5.2 NO. 12 (LOTS: 69 AND 80; PLAN: 4576) BROOKMAN STREET, PERTH - ALTERATIONS AND ADDITIONS TO SINGLE HOUSE SECTION 31 RECONSIDERATION

1. Consultation and Location Plan
2. Development Plans
3. Perspectives
4. Heritage Impact Statement
5. 16 May 2023 Council Minutes and Refused Plans
6. 8 September 2023 Superseded Development Plans
7. Summary of Submissions - Applicant Response
8. Summary of Submissions - Administration Response
9. Determination Advice Notes

Figure 1: Shadow Reduction Between Plans

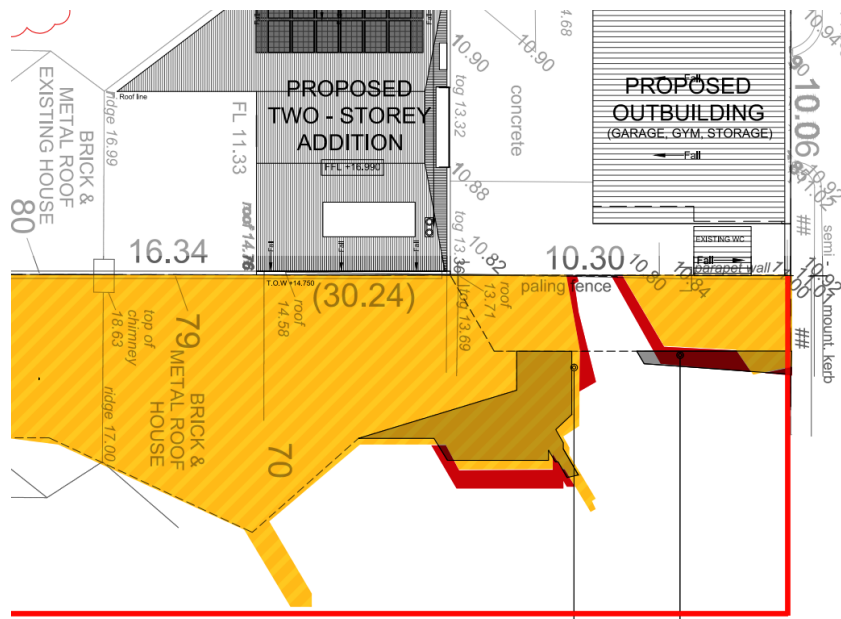
A comparison of the proposed overshadowing, and the overshadowing previously proposed as considered by Council is shown in the **Figure 1** below. The area highlighted in orange represents the portion of the adjoining property that would be overshadowed by the proposed development in the amended plans, measured in accordance with the R Codes at midday on 21 June with the shadow extending to the south, which is when the sun is lowest in the sky and overshadowing is at its worst.

Areas highlighted in red represent areas that would have been overshadowed as a result of the refused plans but would no longer be overshadowed due to the amendments to the plans made. The red line shows the adjoining property’s lot boundary.

The overall proposed overshadowing of No. 10 Brookman Street has decreased from 126.7 square metres (41.7 percent) in the refused proposal, to 121.4 square metres (39.9 percent).
